## 5. Engine Proper

### Cylinder Head Cover

258AE05

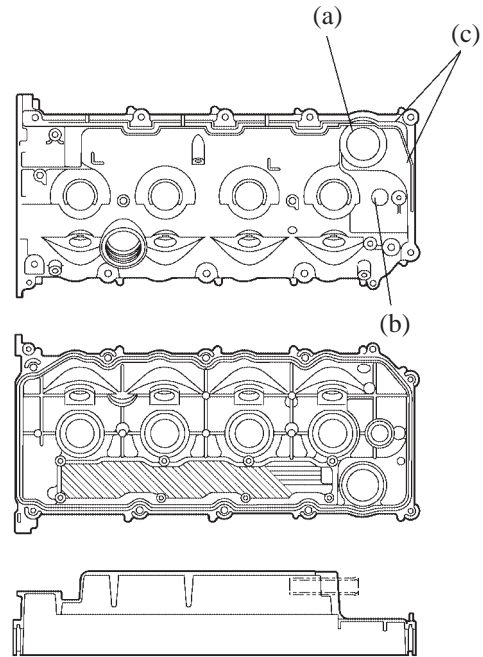
For the purpose of installing the exhaust fuel addition injector, the following changes have been made to the cylinder head:

- (a) Addition of a hole for installing the exhaust fuel addition injector and an oil seal
- (b) Addition of an oil seal for the fuel return outlet for main injector
- (c) Addition of a fuel relief passage, which is used in case of fuel leakage from the exhaust fuel addition injector.
- Change in the seal line of the cylinder head cover gasket to accommodate the addition of the exhaust fuel addition injector

258AE07

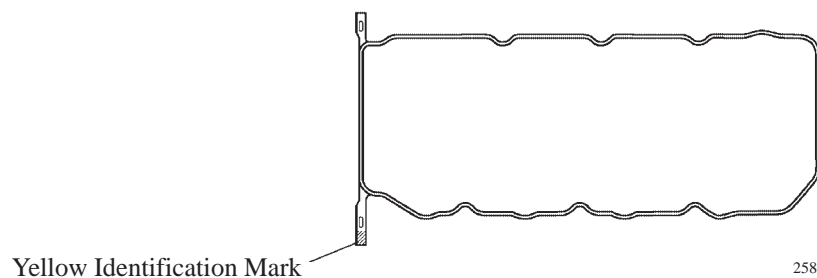
To distinguish from the gasket for the 1CD-FTV engine without D-CAT, the gasket for the 1CD-FTV engine with D-CAT has a yellow mark. This prevents the wrong gasket from being installed.
